Muskat Falls to Happy Valley Interconnection

Questions of Labrador Interconnected Group

Figure 1: Power versus Voltage Profile – Happy Valley Goose Bay

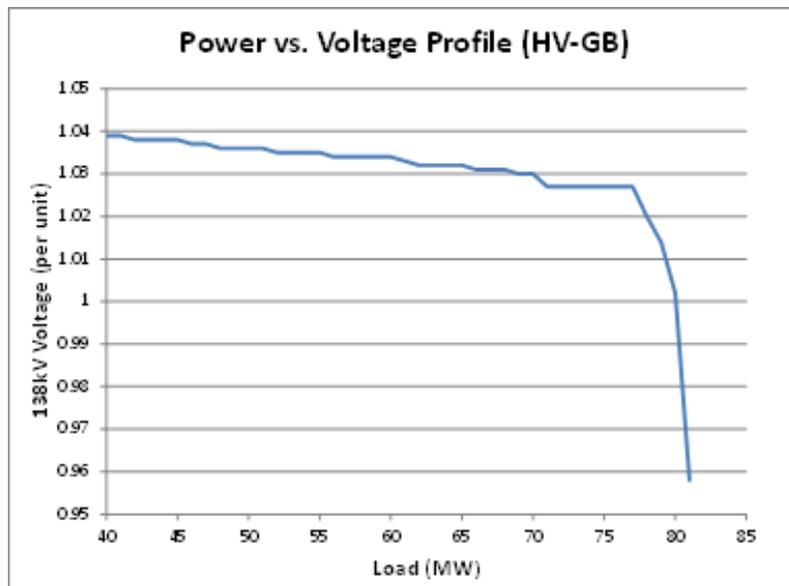
9. Please clarify to what extent loads greater than 77 MW at Happy Valley-Goose Bay are compatible with reliable electric service. More specifically, please describe the consequences of transient or short-term loads that exceed this level, in increments of 1 MW, taking into account existing diesel generation, utility-scale energy storage, curtailment options and any other demand management resources available to Hydro.

The transfer limit of the existing system is 77 MW. Any load above 77 MW will result in voltages below acceptable standards with voltage collapse to follow (Refer to Figure 1). A voltage collapse of this nature will cause a brown out followed by a blackout.
